SUBJECT: REVIEW OF TECHNICAL ASSIST REQUEST FROM REGION III OF THE  
STRUCTURAL INTEGRITY REPORT FROM ADVANCED MEDICAL SYSTEM,  
INC.

SUBJECT: REQUEST FOR TECHNICAL ASSISTANCE IN THE REVIEW OF THE STRUCTURAL  
INTEGRITY REPORT FROM ADVANCED MEDICAL SYSTEMS, INC. (AMS)

**SEISMIC AND STRUCTURAL REVIEW OF ADVANCED MEDICAL SYSTEMS  
LABORATORY FACILITIES**

NUCLEAR REGULATORY FACILITY INSPECTION REPORT ON THE  
ADVANCED MEDICAL SYSTEMS LABORATORY FACILITY

Figure A-2. Ceiling water damage.

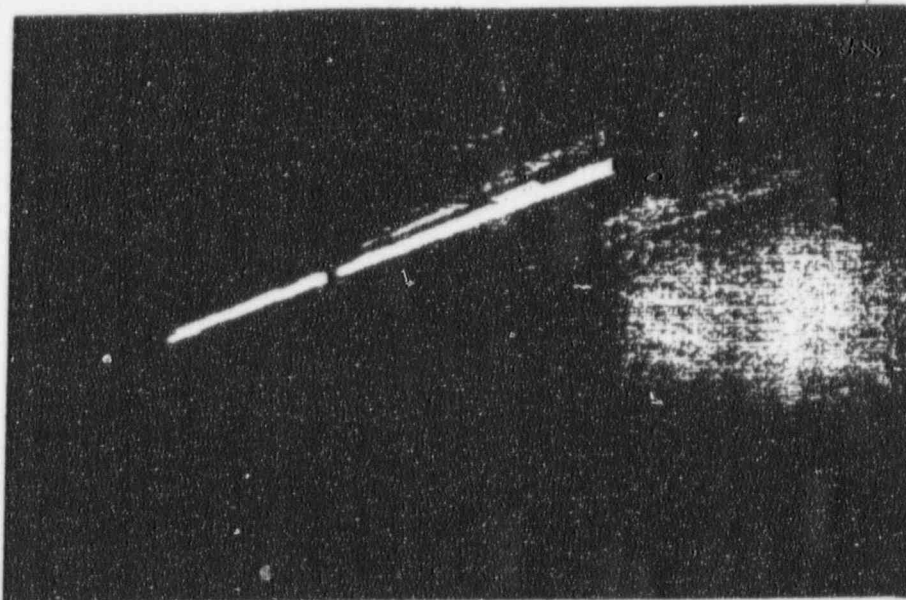
**Agency Comment 4:** The second floor concrete slab in the area where it runs the ceiling of the hallway in front of the hot cell and the radiography room, which exhibits the effects of previous fluid penetration through the slab from above [should be addressed].

5.2 CONCERN-6/4/4: *Evidence of the fluid that penetrated exists on the ceiling adjacent to the hot cell and in front of the radiography room and around the corner of the radiography room into a hallway at the north side of the radiography room. (This was not a concern but a response is needed for clarification.)*

This leakage caused no deterioration of the second floor slab's structural strength, and the fluids did not penetrate the concrete floor slab. There is no visible degradation of the floor slab, and it is highly unlikely there has been any degradation. In addition, the main part of the equipment room is over the radiography room where the floor slab is 2-feet thick.

5.2 RESPONSE: The first inspection of this AMSLF was conducted by this reviewer on April 30 through May 1, 1996. At that time, no ceiling water damage was noticed around the corner of the radiography room into a hallway at the north side of the radiography room.

Figure A-7. Wall movement at purlin in corner.

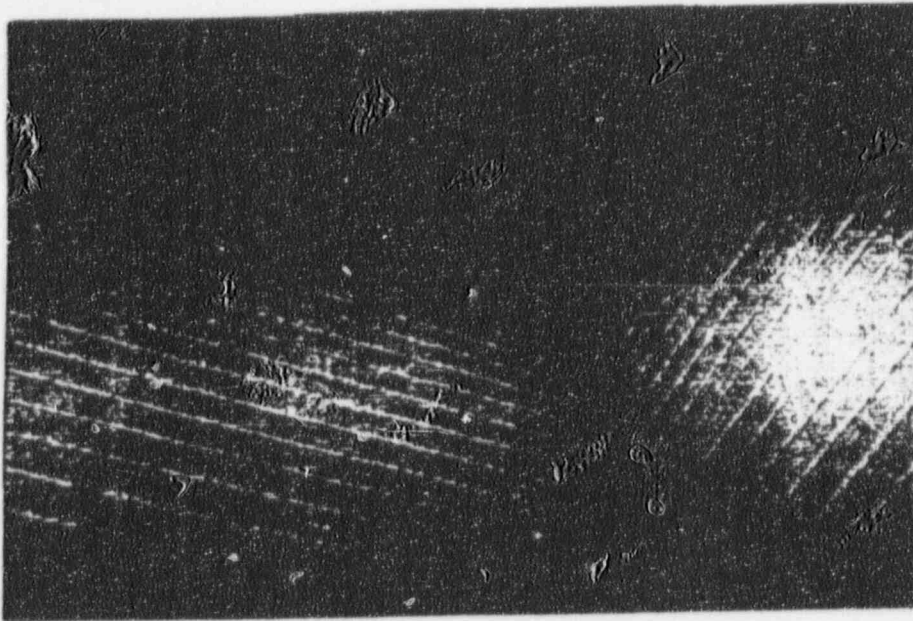
5.14 CONCERN-7/4/14: *In addition to the cracking of the east wall, evidence of lateral loading was found at a point about 17-feet. Rupture of the joints of this wall where the masonry was fit around the purlin as occurred.*

5.14 RESPONSE: It is the opinion of the reviewer that this movement has nothing to do with what has happened at the southeast corner of the building. The biggest problem with the construction of this building is that none of the interior non-load bearing walls were interlocked or tied in with any of the structural members, and most of the non-load bearing walls have separated leaving visible cracks from adjoining walls. The location of the cracking in question is shown in Figure A-8 and, as indicated in the NRC report, the crack opening is approximately one inch. This wall is the west side of a right angle interior wall forming a small room in the southeast corner. If the north side of the interior wall is compared to the paint lines on the roof decking, it is evident that the entire top of the non-load bearing wall has moved northward about one inch. There is no evidence that the purlin has moved southward at this location.
